Staff Report
Board of Adjustment
Special Exception Request
November 24, 2026

Case No.: 26-13 **Hearing Date**: November 24, 2026

Request: A special exception request to construct a dwelling with a 20-foot front yard setback.

Property Address: 3918 240th St, Clear Lake, IA 50428

SITE PLAN

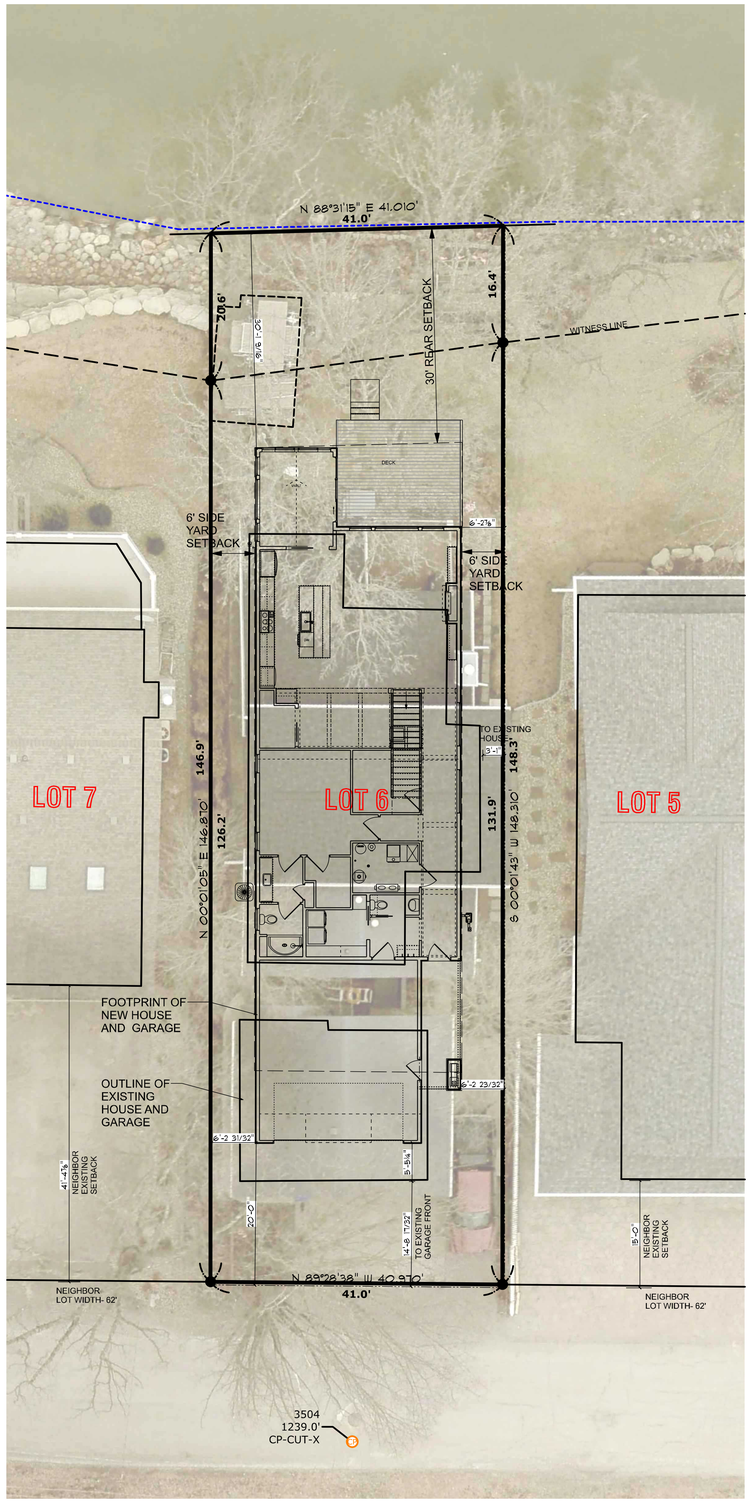
The requested reduction from 30 feet to 20 feet represents approximately 33.3% relief and falls within the 50% numerical limit for a special exception. However, the information provided does not identify the physical circumstances that make compliance with the 30-foot setback practically difficult. Additional information regarding lot dimensions, buildable area, topography, utilities, or other site constraints is needed to evaluate this portion of the standard.

The existing dwelling's location establishes the current setback conditions but does not, by itself, explain why a replacement dwelling cannot comply. The record should identify the circumstances specific to this property that restrict its reasonable residential use under the required front yard setbacks.

The proposal would improve the existing front and side yard setback conditions (the current front yard setback 14 feet). These improvements weigh in favor of the request. Nevertheless, the record should explain why a 20-foot front yard setback is reasonably necessary and whether a lesser reduction would adequately address the identified site constraints.

The information provided does not establish whether feasible alternatives have been evaluated. The applicant should address whether relocating, reorienting, reducing, or modifying the proposed dwelling could meet the required front yard setback or reduce the amount of relief needed.

1. **Front yard setback.** The replacement dwelling shall be located no closer than 20 feet from the front lot line, as measured under the applicable provisions of the Zoning Ordinance.

3. **Approved plans.** Construction shall substantially conform to the site plan and building plans identified in the Board's approval. The approved site plan shall show the dwelling's location and dimensions and its distances from the property lines.

4. **Verification of location.** Before foundation construction, the applicant shall provide documentation acceptable to the Zoning Office verifying the proposed dwelling's location and compliance with the approved setbacks.
